GFA AD-638
(ISSUE 1)

GFA AIRWORTHINESS DIRECTIVE

SUBJECT: Cracks in Engine Mounting Pylon.

Technische Mitteilung Nr.
Technical Note No.
863 - 13 825 - 38

Front view of pylon

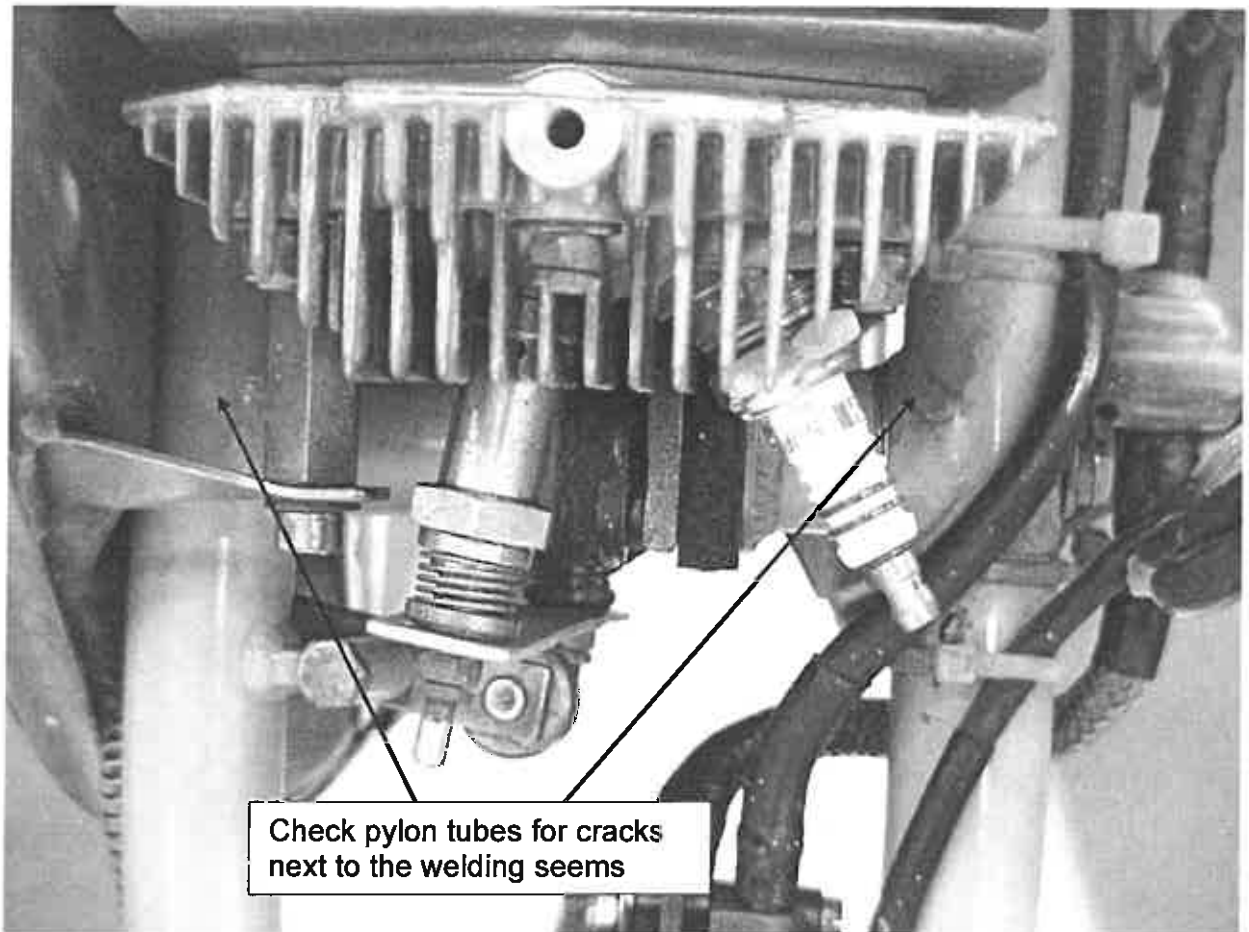
Check pylon tubes at the welding seams of the lower engine mount for cracks - see photographs enclosed to the Appendix of this Technical Note. Clean the affected areas at first if necessary.

Sketch 1: Lower engine suspension, dimension „a“ between the pylon flanges (Rubber mount loose)

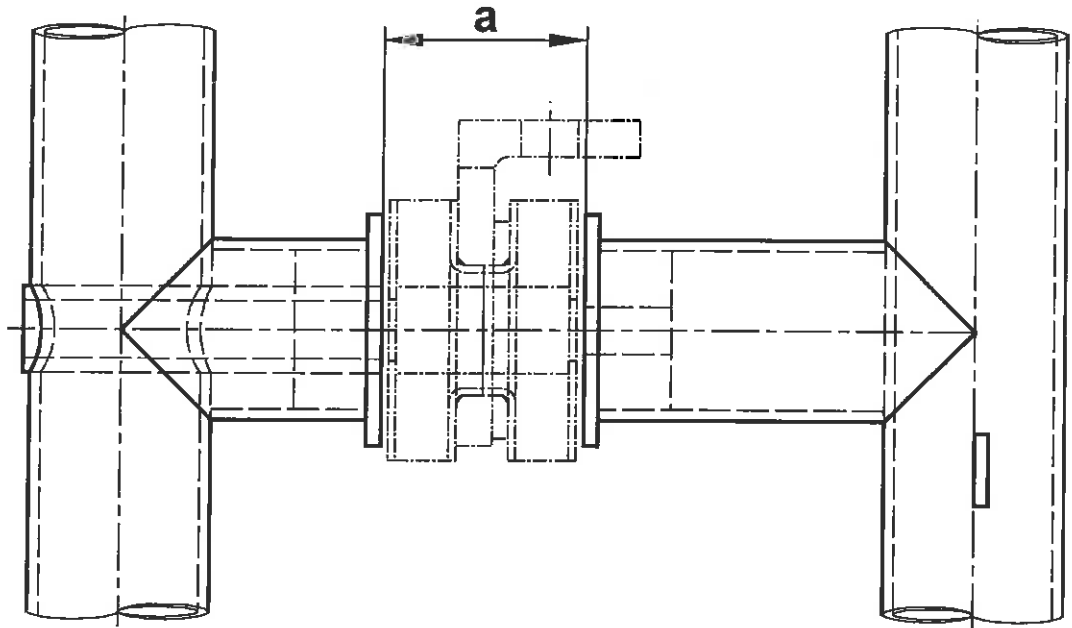
2. Determine the distance between the flanges of the pylon with a slide gauge (see sketch 1, dimension „a“). When measuring dimension „a“ the rubber mounts between the pylon flanges must be loose or may be compressed only slightly.
3. Now the gap between the pylon flanges and the rubber mounts is adjusted by fitting on both sides of the rubber mounts suitable spacers between the pylon flanges and the rubber mounts. The gap is adjusted in a way that after the lower engine suspension bolt is tightened the distance between the flanges is readjusted to the dimension „a“ from the released pylon.

Dimension „x“ = a-26,5mm („x“ = a-1.043 in.)	Thickness of the spacers to be installed:
2,0mm ≥ x > 1,5mm (0.0787 in. ≥ x > 0.05906 in.)	2 x 1,0 mm
1.5mm ≥ x > 1,0mm (0.05906 in. ≥ x > 0.03937 in.)	2 x 0,75mm
1.0mm ≥ x > 0,5mm (0.03937 in. ≥ x > 0.01969 in.)	1 x 1,0 mm, to be installed on the left hand side

Sketch 2: Complete assembly of the lower engine suspension with spacers installed and suspension bolt tightened.

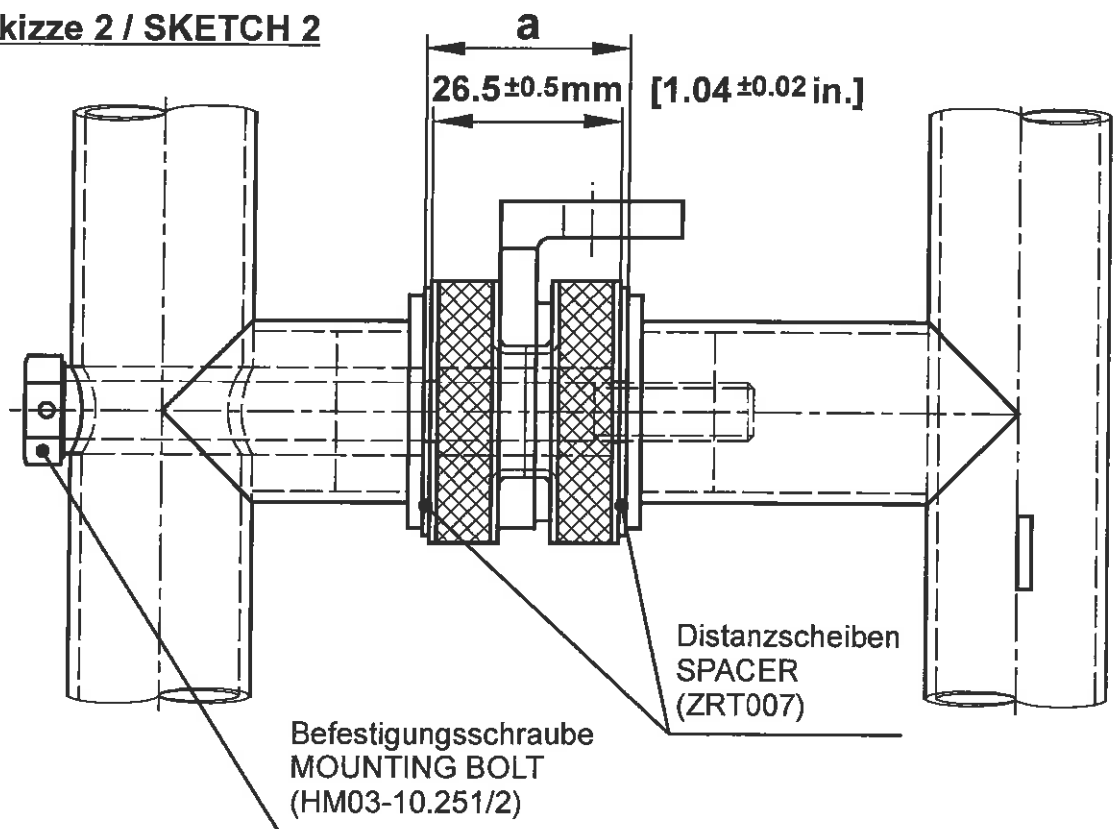
4. When the spacers have been installed insert the lower attachment bolt. Tighten the bolt so far that the rubber mount is compressed to the dimensions listed in the Flight Manual (s. sketch 2, dimension 26,5mm±0,5mm resp. 1.043in.±0.01969 in.):
